COMPILATION OF COMMENTS ON COMMITTEE DRAFT (CC)

IEC 60079-25 ED3

31G/279/CD

TITLE:
Explosive atmospheres - Part 25: Intrinsically safe electrical systems

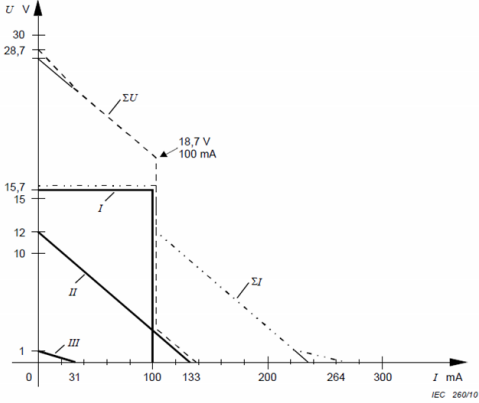
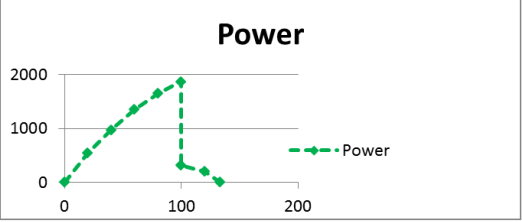
DE-48	491	12.7.7		ed	Revise text to improve understanding Wiped out and inserted	<p>491 If For the case where the L_L is greater than 1% of the L_o, the system is powered from a single</p> <p>492 linear source, and the apparatus has a well-defined inductance and resistance either by virtue</p> <p>492 of its documentation or construction, then the procedures in Annex D may be used to</p> <p>493 determine the applicable L_C /R_C ratio, or to increase the permitted cable inductance L_C.</p>	Accepted in principle, see also US comment
